# Preferred Project Report

MP09\_0192 Concept Plan and Stage 1 works

164 Station Street

June 2013

FIGURE 2 – THE AMENDED MASTERS STORE LOCATION AND DESIGN

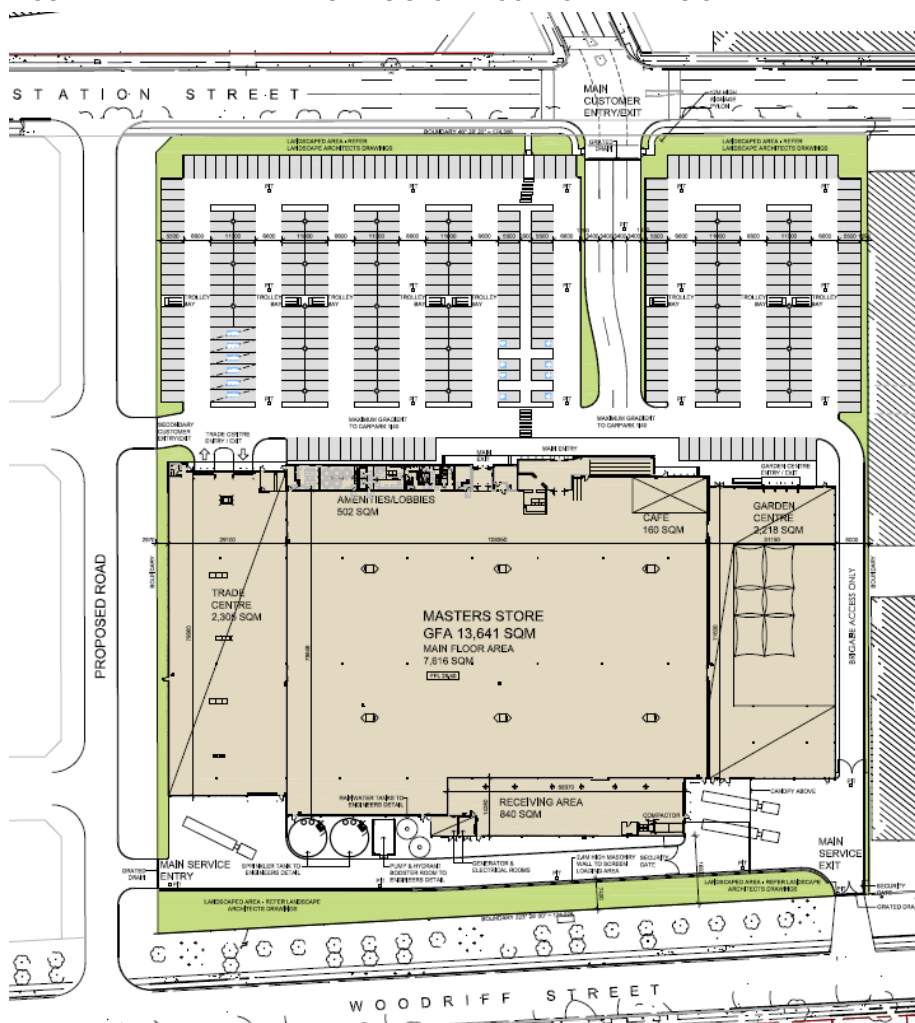
The alternative siting suggestion provided by DPI (refer Figure 1) to orientate the Masters Store to address Woodriff Street to the east was given detailed consideration however, it is not considered to provide the optimal design outcome for the following reasons:

- DPI correspondence indicates a preference to channel the majority of traffic via Station Street which already handles larger traffic volumes due to the special events uses on its western side. However, the layout in Figure 1 could result in higher traffic volumes along Woodriff Street.

A number of options were explored orientating the Masters Store to the south and to the west. Orientating Masters to the south had some benefit by placing the back of house areas adjacent to the back of the retail tenancies on the Centro site. However, it is considered more appropriate to orientate it to the east to avoid large expanse of car parking onto the proposed residential area and to allow main customer access from Station Street as shown in Figure 2.

- To minimise acoustic and privacy issues to the residents on Woodriff Street by orientating the car park (the active area) away from this boundary.
- Allows for adequate treatment including a landscaped mound to screen the back of house area to Woodriff Street where there is an existing large vegetated verge.
- Traffic will enter the site predominantly from Station Street avoiding increased traffic on Woodriff Street.

- The parking area is adjacent to the plaza and tavern providing an extension of active public domain areas to the existing sporting precinct to the west.
- The residential flat buildings have been designed to avoid direct overlooking of the Masters Store.

FIGURE 3 – THE AMENDED RESIDENTIAL LOCATION AND DESIGN

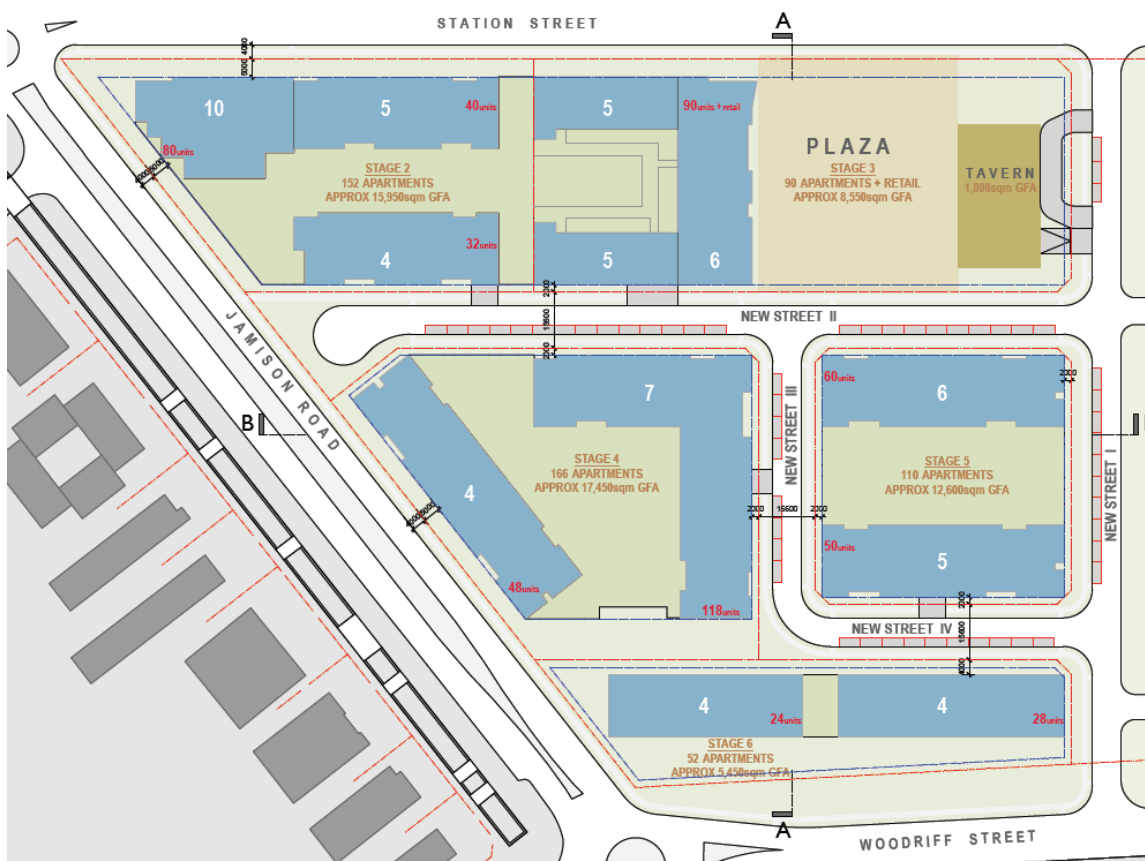
*Extend a public street between Station Street and Woodriff Street along the northern boundary to provide a better interface with the Centro site to the north.*

- A street along the northern boundary is not considered appropriate as the existing retail provided along the southern boundary of the Centro site is orientated north towards the main shopping precinct and away from the subject site. It is considered highly unlikely that any retail on the Centro site would orientate itself away from the main retail uses in the future. Accordingly, a street in this location would not provide a high quality public domain presentation or the best long-term outcome for the site.

- Compliance with SEPP 65 including solar access, building separation and privacy.
- An appropriate internal street layout which will provide access to basement car parking associated with the residential flat buildings, tavern, ground floor retail and plaza areas.
- A high level of open space and public amenity through a landscape design which incorporates landscape, communal areas, public plaza areas and visual vegetation buffers.
- Residential buildings which respond to the low density residential development to the south and east and provide an attractive and consistent streetscape.
- Gateway presentation at the corner of Station Street and Jamison Road through reallocation of height.

It should be noted that the GFA, apartment number and parking rates do not change as a result of the Preferred Project and remain as proposed in the EA.
